Client
Manchester Metropolitan University

Project
Grosvenor Lifecycle Refurbishment Project

Drawing Title
UPGRADE PROPOSALS FOR THE EXISTING HERITAGE DOORS & SCREENS

C+A JOB NO.	PROJECT - ORIGINATOR - VOL. - LEVEL - TYPE - ROLE - NUMBER	REV.
10034	1002B-CAA-ZZ-GF-DR-A-017118	C03

GROUND FLOOR PLAN

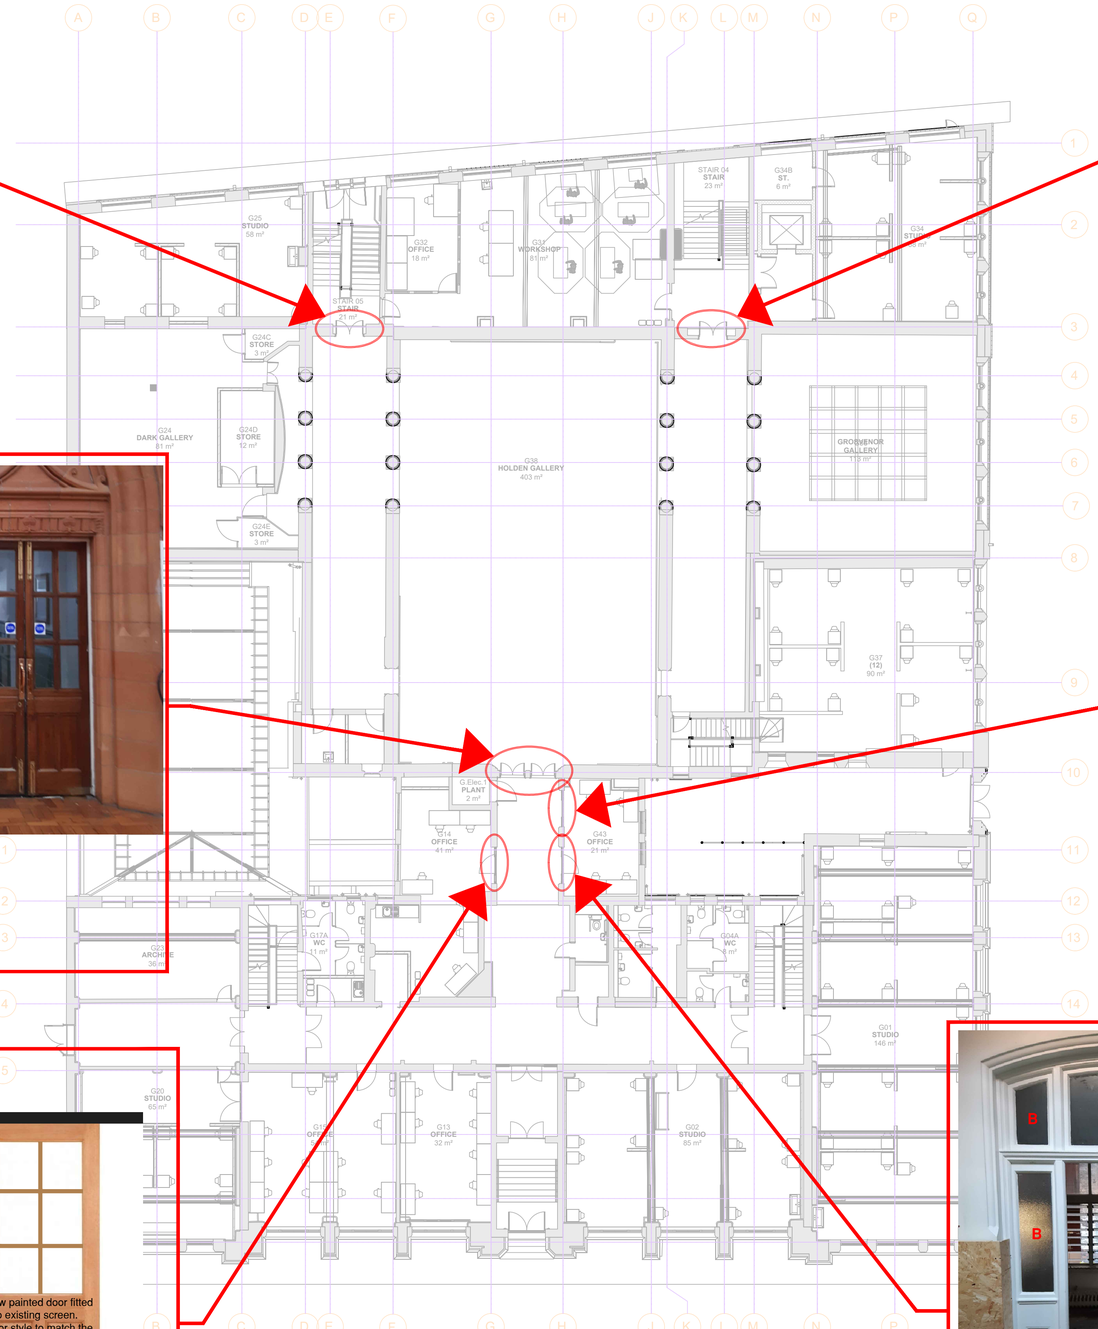
Rev.	Description	Date
C03	Doors DI.GF.014 & DI.GF.043 amended to be similar in style to the existing Holden Gallery doors in accordnace with the Heritage Planning Officers comments.	31.05.2024
C02	Door D1.GF.014 amended to show the top solid panels retained due to ceiling level behind in lieu of replacing with glass.	13.07.2023
C01	Issued For Clarification & Construction.	13.03.2023
P1	First Issue	04.11.2022

Door No. D1.GF.014 (Existing Screen Retained - Single *Non-Original* Door Removed)
Proposal:
- The existing door is not original and is to be removed. This is to be replaced with a new fire resisting door similar to the style of the existing Holden Gallery Doors.
- The screen is to be refurbished with a light sanding then re-painted.
- **A** - Denotes existing timber panel to be removed and new fire resisting (Pyroswiss or similar) clear glass installed, with suitable lorient (or similar) beading system.
- **B** - Denotes existing glass to be removed and clear fire resisting (Pyroswiss or similar) glass installed, with suitable lorient (or similar) beading system.
- **C** - Denotes existng panels to remain.

Door No. D1.GF.043 (Existing Screen Retained Single *Non-Original* Door Removed)
Proposal:
- Building Control require this door & screen to be fire resisting.
  The existing door is not original and is to be removed. This is to be replaced with a new fire resisting door similar to ththe style of the existing Holden Gallery Doors.
- The screen is to be refurbished with a light sanding then re-painted and have a clear intumescent (fire resisting) lacquer applied over new paintwork.
- **B** - Denotes existing glass to be removed and clear fire resisting (Pyroswiss or similar) glass installed, with suitable lorient (or similar) beading system.
- **C** - Denotes existng panels to remain.
